CLV DETENTION & ENFORCEMENT ISOLATION CELL ADDITION
HORIZONTAL CONTROL PLAN
SHEET C-3
3 OF 15
DRAWING NO. 513-552R
12/11/15
Randy M. McConnell
CIVIL
EXP. 12/31/2015
No. 016255
PROFESSIONAL ENGINEER
STATE OF NEVADA

CLV DETENTION & ENFORCEMENT ISOLATION CELL ADDITION

TITLE CLV DETENTION & ENFORCEMENT ISOLATION CELL ADDITION		PREPARED FOR CITY OF LAS VEGAS						ADDED CONSTRUCTION PLAN SHEET FOR SAW RP AND HC PARKING STALL	
SHEET C-6.1 9 OF 15		SHEET SIDEWALK CONSTRUCTION PLAN		BID# 13.48691-TB H# 48691 DATE: MARCH 2015 DESIGNED BY: HES SUBMITTAL STAGE: FINAL DRAWN BY: HES CHECKED BY: RMM		PREPARED BY		NO.		DATE	
DRAWING NO. 513-55-2F										REVISIONS

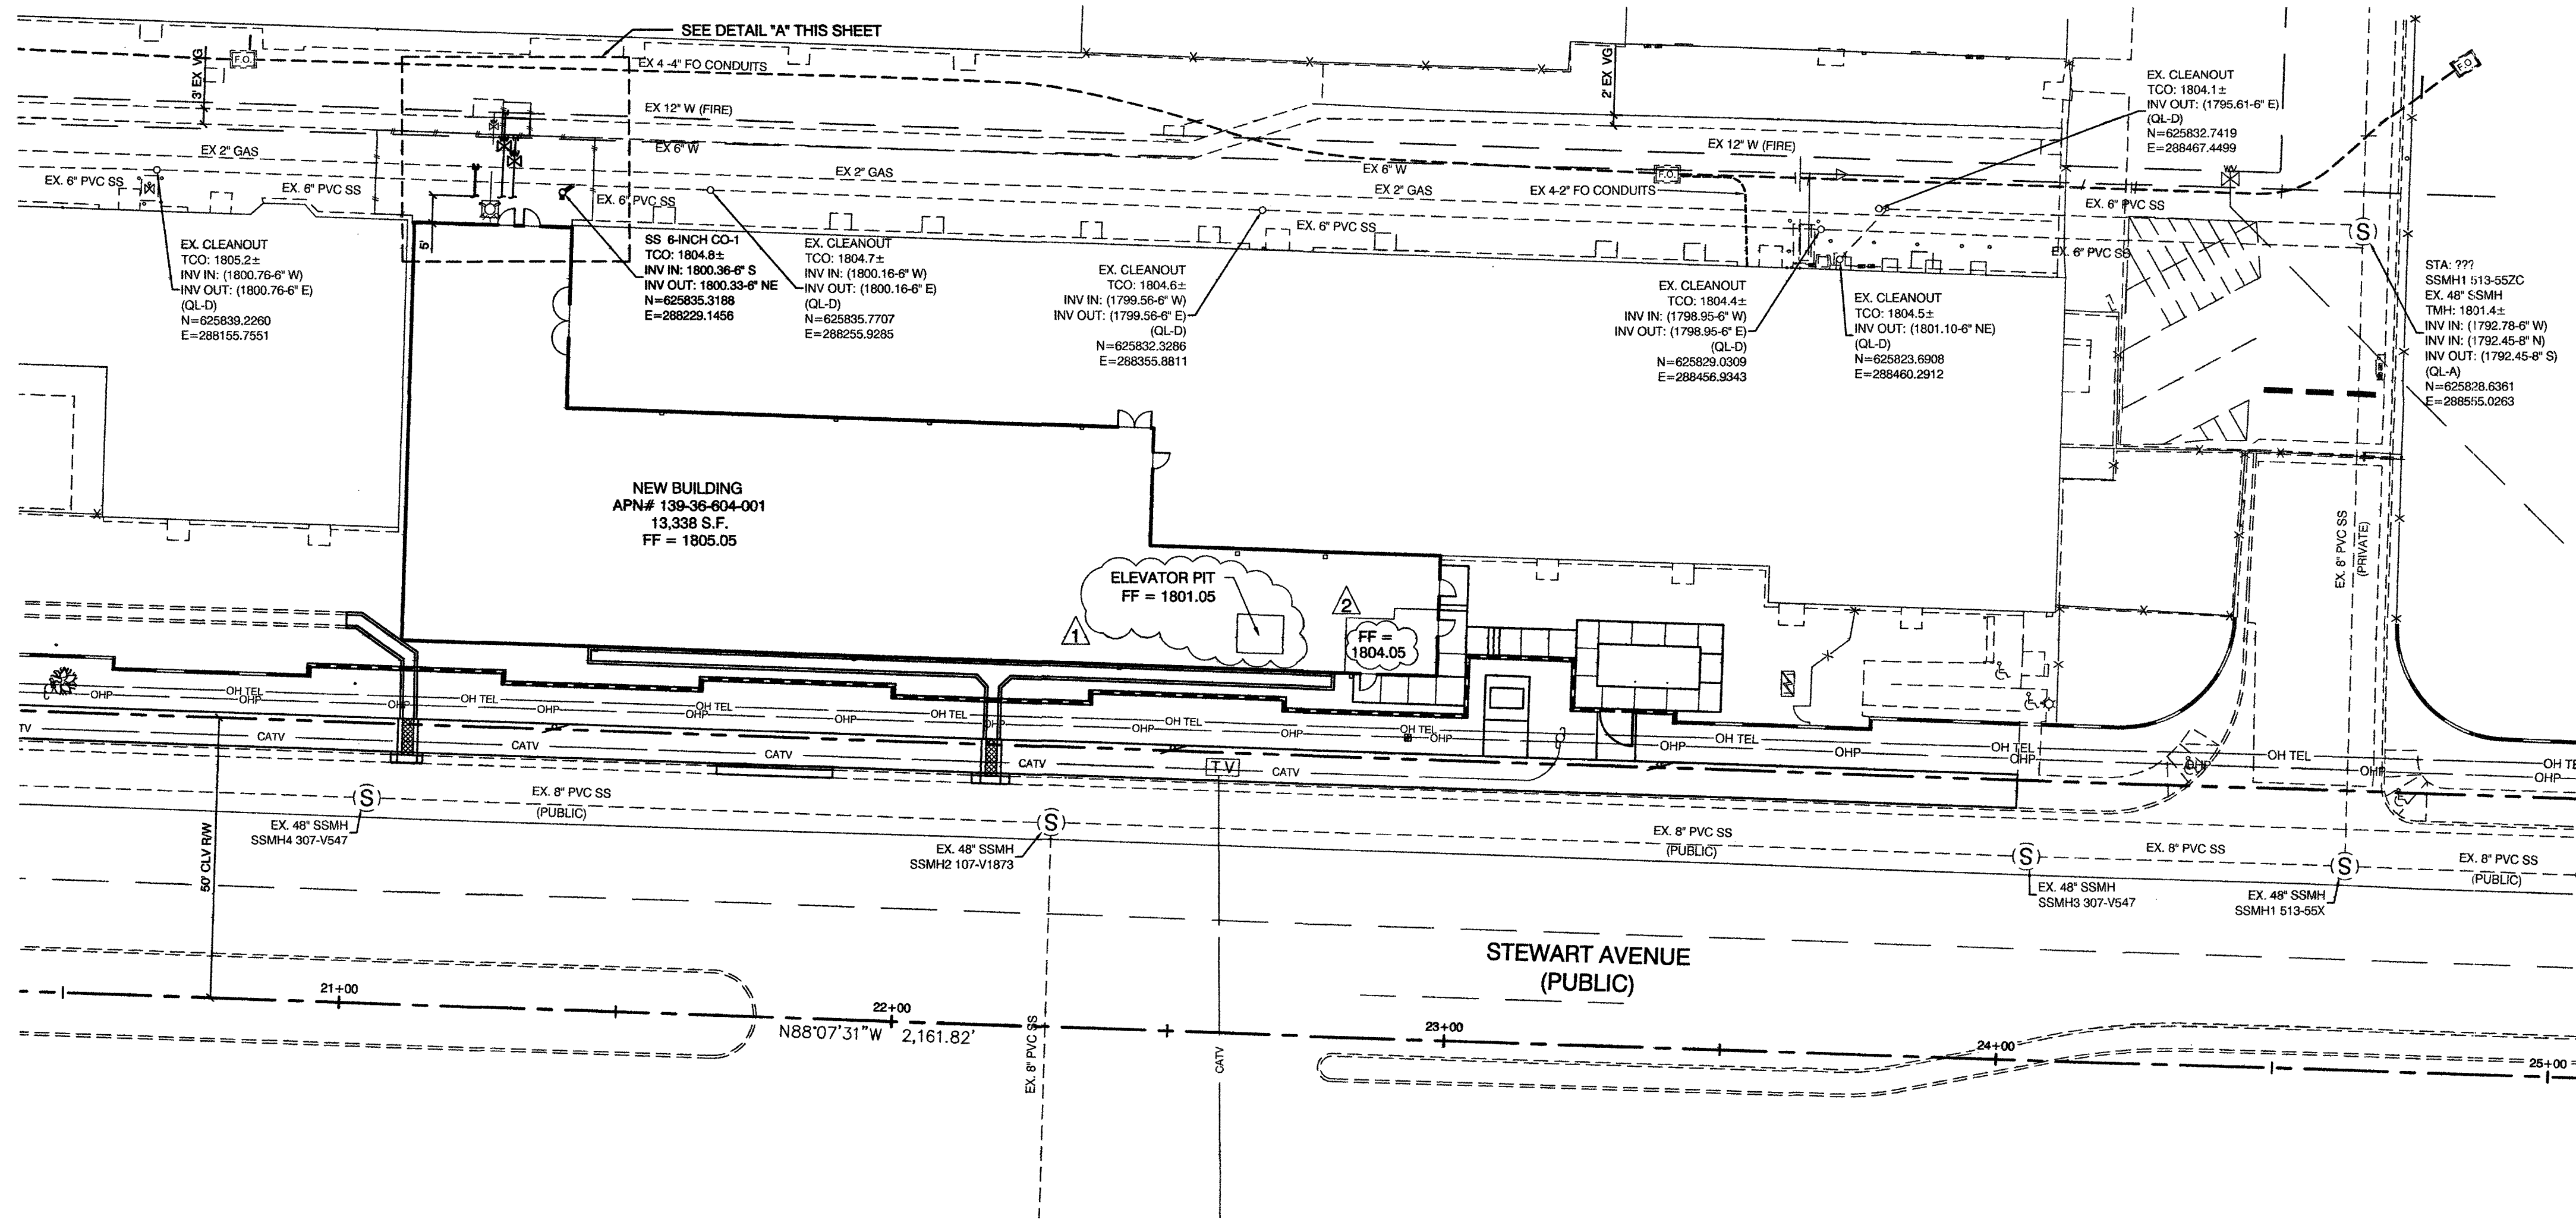
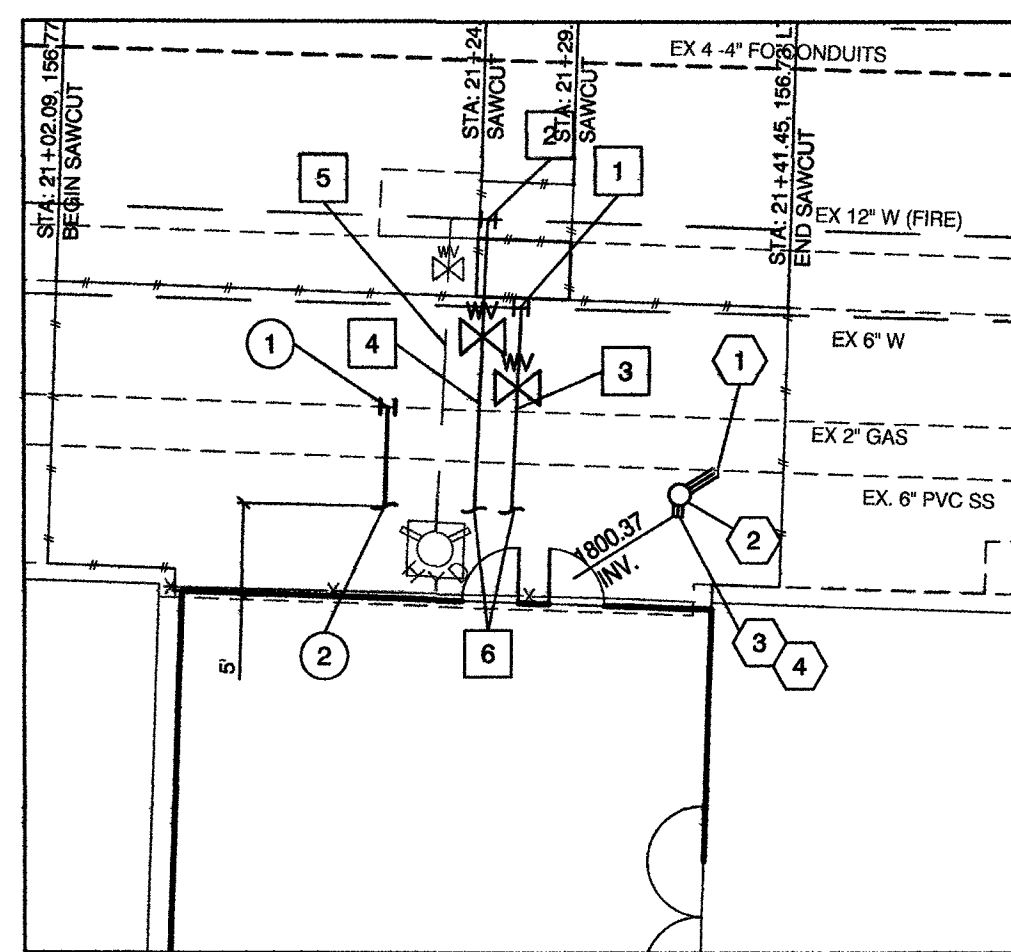
ADDED ELEVATOR PIT FF, REVISED SHT NUMBER	06/17/15	02/17/16	NO.	DATE
BASED FF ELEVATION IN UTILITY ROOM				
REVISIONS				
DEPARTMENT OF PUBLIC WORKS CAPITAL PROJECT MANAGEMENT				
PREPARED BY	DESIGNED BY	DRAWN BY	CHECKED BY	
CITY OF LAS VEGAS	HES	HES	RMM	
BID# 13-48891-TB	DATE: MARCH 2015	SUBMITTAL STAGE:	FINAL	
H# 48891				
CLV DETENTION & ENFORCEMENT ISOLATION CELL ADDITION UTILITY PLAN				
SHEET C-5 7 OF 15				
DRAWING NO. 513-55ZR
